SIB 52 08 22

HEADREST IS UNCOMFORTABLE FOR SOME OCCUPANTS

This Service Information Bulletin (Revision 1) replaces SI B52 08 22 **dated November 2022**.

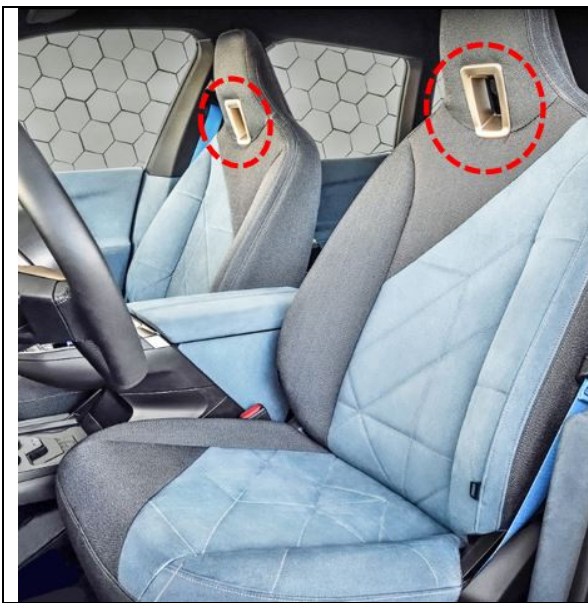
The decorative hard plastic piece, centered in the front seat's headrest (circled area), may contact a person's head when they are between 4' 10" and 5' 6" in height.

In the case of customer concern, for applicable vehicles produced prior to July 1, 2023, there is a push-in cushion insert available to plug up the square hole in the front seat headrest(s) that provides additional support.

1. For vehicles produced from Start of Production up to July 1, 2023, there is push-in cushion insert available to plug up the square hole in the headrest. It is inserted from the front of the seat and pulled through from the rear of the seat to lock into position.

2. The insert slides thru the square decorative hard plastic piece centered in the front seat's headrest.
